Comments #294, 296
Proposed Responses

IEEE P802.3bj
100 Gb/s Backplane and Copper Cable
Task Force

John D'Ambrosia, Dell

San Diego, CA, USA, July 2012

Figure 94-1—100GBASE-KP4 PMA and PMD relationship to the ISO/IEC Open Systems Interconnection (OSI) reference model and the IEEE 802.3 CSMA/CD LAN model

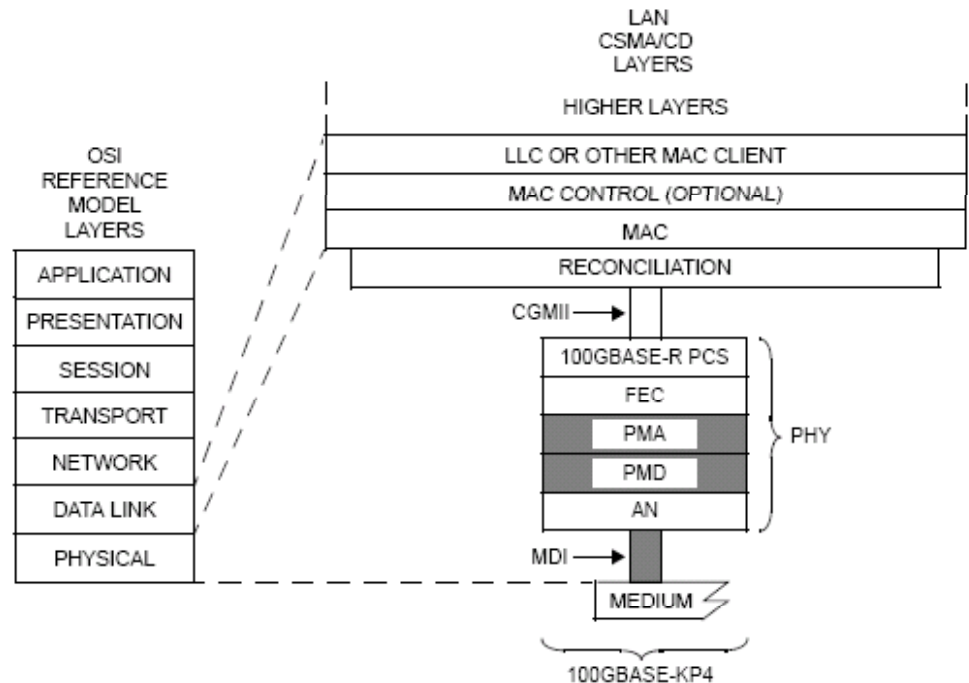
Table 94-1 lists the physical layer clauses associated with 100GBASE-KR4 PMD, and states that Clause 83A CAUI is optional. However, CAUI is based on 10 lanes of 10.3125 Gb/s, and therefore would also require two instantiations of the Clause 83 PMA sublayer

Comment #294 Overview

- For Clauses 94
- CAUI – x10 (802.3ba)
- Generic architecture drawing does not help clarify x10 and x4 PMA / CAUI Implementations
- Clause 83 PMA [m:n] above FEC
- Clause 94 PMA below FEC

Table 94-1 need to include Clause 83 PMA as optional. Add a note to 83A CAUI line that states if 83A CAUI is present then two instantiations of Clause 83 PMA [(n:10) and (10:n)] must be present. It is also assumed that a CAUI would actually reside between two clause 83 PMA sublayers that would reside above the FEC sublayer. This is brought up then, because now we need to define the PMA Sublayer positioning in a fashion similar to what is currently done in 83.1.4. This also would include addressing the MMD addresses for multiple PMA sublayers. also, i believe from prior work it was stated that if the adopted FEC approach were to be used - you could not change the number of lanes until the data link was "de-FEC'd".

- **Modify 94.1 to**

This clause specifies the Physical Medium Attachment (PMA) sublayers, Physical Medium Dependent (PMD) sublayer, and medium for the 100GBASE-KP4 PHY. A 100GBASE-KP4 physical shall include the required sub-layers and may include the optional sub-layers specified in Table 94-1.

When forming a complete 100GBASE-KP4 Physical Layer, the following guidelines apply:

- (a) The 100GBASE-KP4 PMA specified in 94.2 shall connect with the FEC through the PMA service interface specified in 94.2.1.
- (b) The 100GBASE-KP4 PMD specified in 94.3 shall connect with the 100GBASE-KP4 PMA through the PMD service interface specified in 94.3.1.
- (c) If one or more CAUI interfaces are implemented between the FEC and the RS, each CAUI interface shall include a pair of PMA sub-layers, as specified in Clause 83.. Refer to 83.1.4 for additional guidance.

- **Add entry to Table 94.1**

- 83 PMA – Optional

Figure 92-1—100GBASE-CR4 PMD relationship to the ISO/IEC Open Systems Interconnection (OSI) reference model and the IEEE 802.3 CSMA/CD LAN model

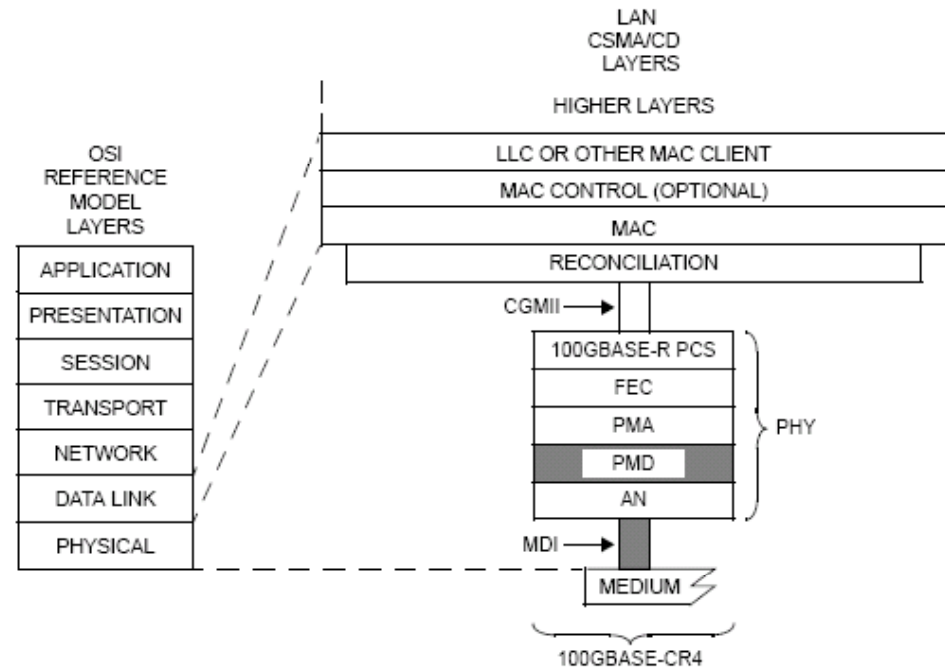
Table 92-1 lists the physical layer clauses associated with 100GBASE-CR4 PMD, and states that Clause 83A CAUI is optional. However, CAUI is based on 10 lanes of 10.3125 Gb/s, and therefore would also require two instantiations of the Clause 83 PMA sublayers. CAUI implementations can not reside inside FEC'd portion of link.

Also, the PMA sublayer beneath the FEC sublayer SHALL be a [4:4] PMA sublayer, and not the generic PMA sublayer as specified in Clause 83.

The same problem applies to Clause 93 as well.

Comment #296: Problem Overview

- For Clauses 92 & 93
- CAUI – x10 (802.3ba)
- Generic architecture drawing does not help clarify x10 and x4 PMA / CAUI Implementations
- Clause 83 PMA [m:n] above FEC
- Clause 83 PMA [4:4] below FEC

Add a note to 83A CAUI line that states if 83A CAUI is present then two instantiations of Clause 83 PMA [(n:10) and (10:n)] must be present. It is also assumed that a CAUI would actually reside between two clause 83 PMA sublayers that would reside above the FEC sublayer. This is brought up then, because now we need to define the PMA Sublayer positioning in a fashion similar to what is currently done in 83.1.4. This also would include addressing the MMD addresses for multiple PMA sublayers. also, i believe from prior work it was stated that if the adopted FEC approach were to be used - you could not change the number of lanes until the data link was "de-FEC'd". This means the following two things -

This needs to be captured in a section similar to the guidelines applying to partitioning of PMAs on page 139 of P802d3rev_d3p1.pdf on Page 139. Also, this needs to include something that states that the PMA below the FEC sublayer has to be a [4:4] PMA sublayer.

- Add after 1st paragraph in 92.1
 - When forming a complete 100GBASE-CR4 Physical Layer, the following guidelines apply:
 - (a) If FEC is implemented, the PMA specified in Clause 83 shall connect with the FEC through the PMA service interface specified in 83.3, with $p=4$ input lanes.
 - (b) When connected to the Clause 91 FEC, the PMD specified in Clause 92 shall connect with the PMA specified in Clause 83 through the PMD service interface specified in 92.2.
 - (c) If one or more CAUI interfaces are implemented between the FEC and the RS, each CAUI interface shall include a pair of PMA sub-layers, as specified in Clause 83. Refer to 83.1.4 for additional guidance.

- Add after 1st paragraph in 93.1
 - When forming a complete 100GBASE-CR4 Physical Layer, the following guidelines apply:
 - (a) If FEC is implemented, the PMA specified in Clause 83 shall connect with the FEC through the PMA service interface specified in 83.3, with $p=4$ input lanes.
 - (b) When connected to the Clause 91 FEC, the PMD specified in Clause 92 shall connect with the PMA specified in Clause 83 through the PMD service interface specified in 93.2.
 - (c) If one or more CAUI interfaces are implemented between the FEC and the RS, each CAUI interface shall include a pair of PMA sub-layers, as specified in Clause 83. Refer to 83.1.4 for additional guidance.
